SUBJECT: Draft Final Explanation of Significant Differences to the Action Memorandum for the Area 16 Abandoned Landfill, Northeast Corner Operable Unit, Lake City AAP

**Explanation of Significant Differences
to the Action Memorandum
for the
Area 16 Abandoned Landfill
Northeast Corner Operable Unit
Lake City Army Ammunition Plant
Independence, MO**

REGARDING: Area 16 Maintenance Investigation
Lake City Army Ammunition Plant
Independence, Missouri

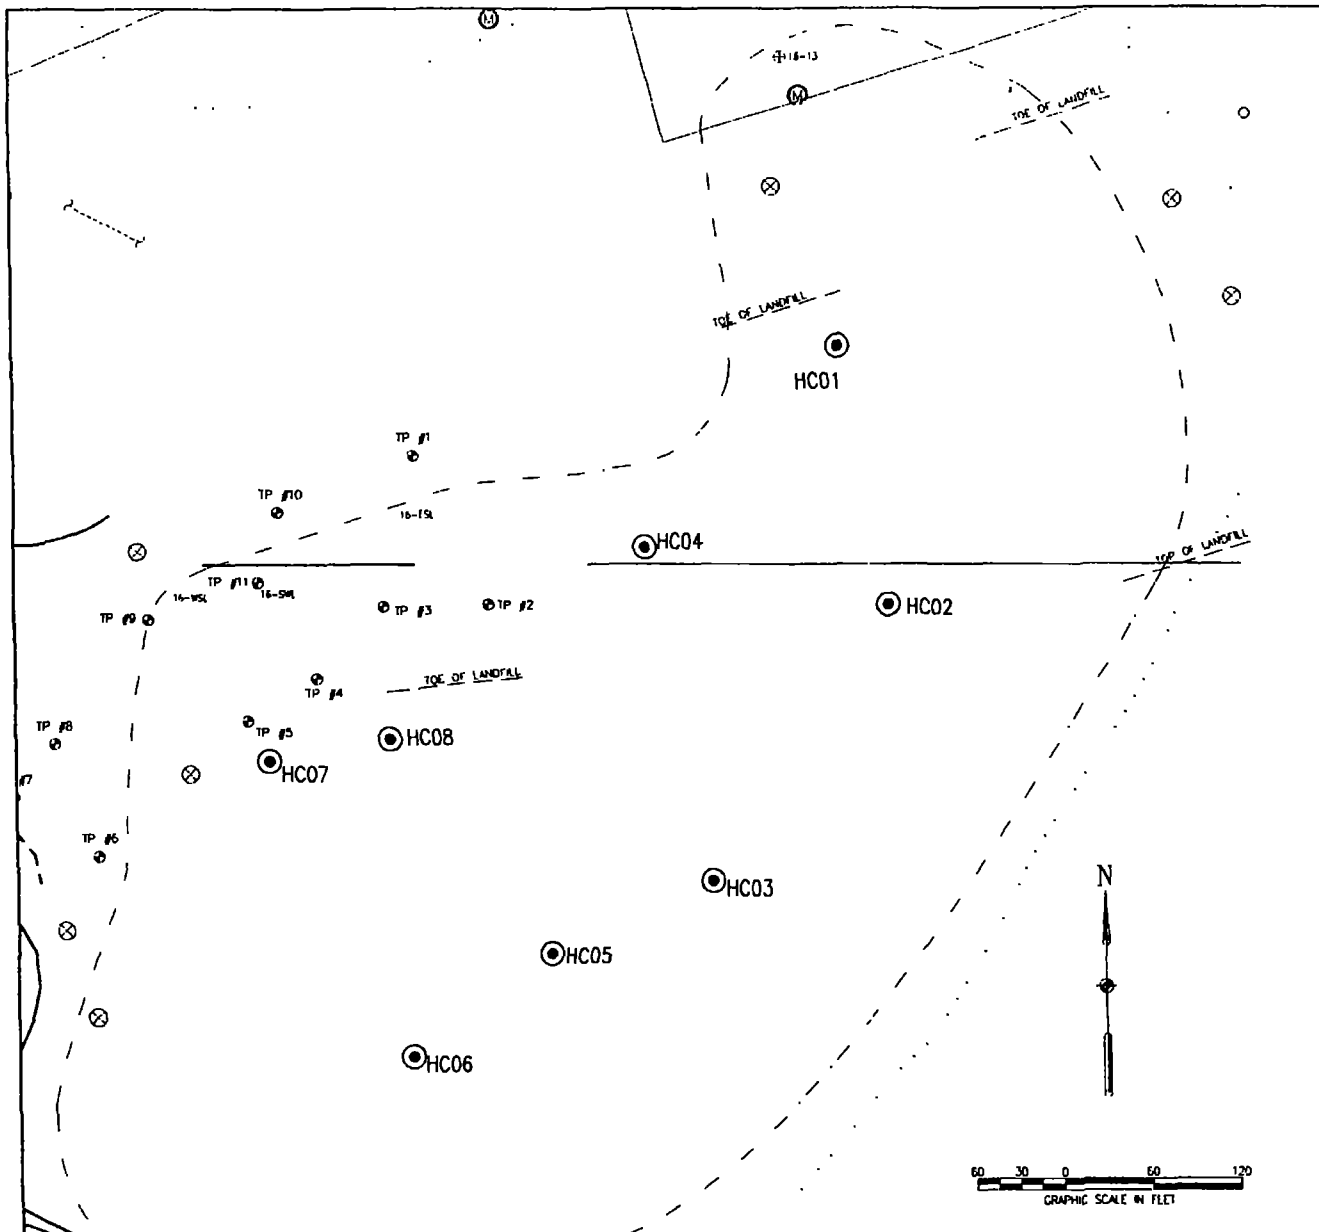
TN&A used a geoprobe rig with an auger (ASM D1452) to determine the thickness of the cover. In the same location, TN&A also used the geoprobe to collect two Shelby tube samples (ASTM D1587) of the cover material. These samples were analyzed in the laboratory for soil classification (ASTM D2487) and hydraulic conductivity (ASTM D5084). This procedure was followed at eight locations on the landfill as shown on Figure 1.

Based on the laboratory results which are included in Appendix A and the field investigation, the cover material generally meets the regulatory requirements. There is a minimum of 24 inches of clay covering the site. The soil is capable of supporting vegetation. The evidence of this is the growth of vegetation on the site. However, three samples (HC01, HC06, and HC08) have less than 12 inches of soil capable of sustaining vegetation overlying the clay. All samples except HC08 have a hydraulic conductivity less than 1×10^{-5} cm/s at depths in the bottom 24 inches of the cover. These results are shown in the following table. Sample locations are shown in Figure 1.
